ST/SG/AC.10/C.3/2004/29  
7 April 2004

**MISCELLANEOUS PROPOSALS OF AMENDMENTS TO THE MODEL REGULATIONS  
ON THE TRANSPORT OF DANGEROUS GOODS**

Manual of Tests and Criteria, Appendix 5, Example of a test method for vent sizing

Transmitted by the International Council of Chemical Associations (ICCA)

**Figure A5.1: 10 LITRE VESSELS FOR VENTING TESTS"**

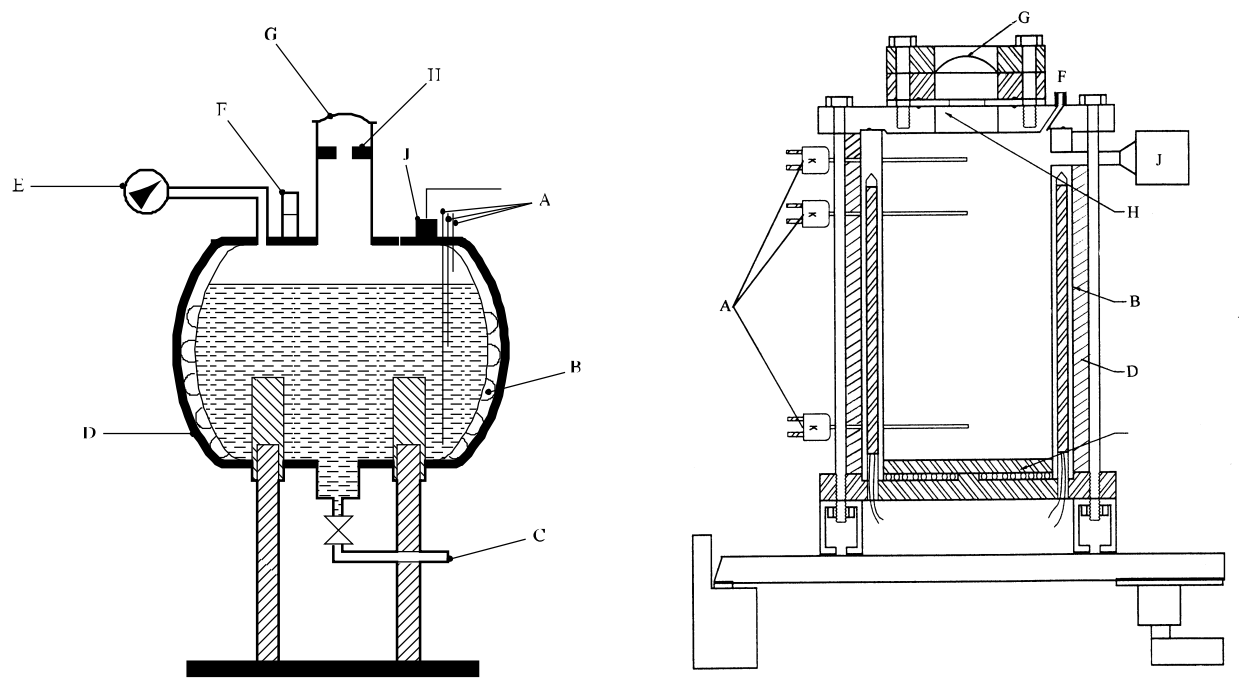
- Inclusion of a reference to the applicability of the test method for IBCs, criterion for maximum acceptable pressure allowed during emergency venting of IBCs and addition of calculation example for IBCs,
- Inclusion of test vessel as developed by OPPSD in corporation with New Mexico Tech, USA, and
- Correction of equations (1) and (3) and the calculation examples (extra brackets).

The reduced scale tank consists of a stainless steel test vessel with a gross volume of 10 l. The top of the tank is provided with either a 1 mm opening which simulates the pressure relief valve (PRV) of the ~~IBC or portable~~-tank or a real PRV of a diameter which is scaled using the vent area to vessel volume ratio. A second opening simulates the emergency vent opening and is closed by a bursting disk. The diameter of this vent opening can be varied by using orifice plates with different apertures. The bursting pressure of the disk fixed to the 10 l vessel should be equal to the maximum rupture pressure of the bursting disks to be fitted to the ~~IBC or portable~~-tank. This pressure should be lower than the test pressure of the ~~portable~~-tank involved. Usually, the bursting pressure is set at a level that can cope with the pressures encountered during normal transport conditions such as hydrostatic pressure from the liquid due to turn over of the ~~portable~~-tank, slopping of the contents, etc. The 10 l vessel should be provided with a bursting disk with a set pressure in the range of the disk(s) fitted on the tank or IBC as to be used in transport. The minimum test pressure of the portable tank should be 4.0 bar gauge (see paragraph 4.2.1.13.4 of the Model Regulations). A bursting disk set pressure in the range 3.0 to 3.5 bar gauge is appropriate. For safety, it is recommended to provide the test vessel ~~should also be provided~~ with an extra bursting disk (bursting pressure approximately 80% of the design pressure of the 10 l test vessel) with a large opening for additional emergency venting of the test vessel in the event that the chosen orifice diameter is too small.

- 
- (A) Thermocouples (two in liquid on one in vapour space)
  - (B) Heating coil/[heating cartridge](#)
  - (C) Drain line, [optional](#)
  - (D) Insulation
  - (E) Manometer, [optional](#)
  - (F) Pressure relief valve, [optional](#)
  - (G) Bursting disk
  - (H) Orifice plate
  - (J) Pressure transducer [or pressure relief valve & transducer on tee](#)
-
